Access Compliance Report

Public Rights-of-Way

(Curb Ramps)

Intersection ID: 2786	Main Street: CHAVEL_LN	Cross Street: ROCK_STREAM_DR	Location: NW
ADA ID: BAF3770F03A1	Ramp Type: Perp	Initial Pass/Fail: Fail	Overall Compliance: No
		Severity Score: 8.75

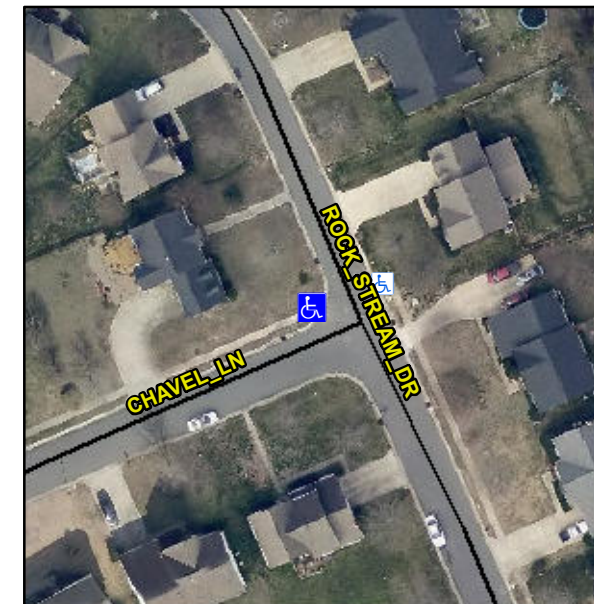
Not Found, R304.5.1

Compliance	Description	Data	Compliance	Description	Data
N/A	Ramp Length (in)	94.0	Yes	Ramp Slope (%)	5.5
No	Ramp Width (in)	46.5	Yes	Ramp XSlope (%)	0.3
N/A	Flare Type LT	N/A	N/A	Flare Type RT	N/A
N/A	Flare Slope LT (%)	N/A	N/A	Flare Slope RT (%)	N/A
N/A	Flare Traversable LT?	N/A	N/A	Flare Traversable RT?	N/A
N/A	Landing Length (in)	N/A	N/A	DWS Provided?	N/A
N/A	Landing Width (in)	N/A	N/A	DWS Contrast?	N/A
N/A	Landing Slope (%)	N/A	N/A	DWS Length (in)	N/A
N/A	Landing X Slope (%)	N/A	N/A	DWS Full Width?	N/A
N/A	Landing Curb? (Y/N)	N/A	N/A	DWS Offset (in)	N/A
N/A	Shared Landing?	N/A			
N/A	Gutter Ponding?	N/A	N/A	Gutter Slope (%)	N/A
N/A	Gutter Lip Ht (in)	N/A	N/A	Gutter X Slope (%)	N/A
N/A	Painted X Walk1?	No	N/A	Painted X Walk2?	N/A
	X Walk 1 Direction	To E		X Walk 2 Direction	N/A
N/A	X Walk 1 Width (in)	N/A	N/A	X Walk 2 Width (in)	N/A
	X Walk 1 Slope (%)	3.1		X Walk 2 Slope (%)	N/A
	X Walk 1 X Slope (%)	2.9		X Walk 2 X Slope (%)	N/A

Remove & Replace Entire Ramp.
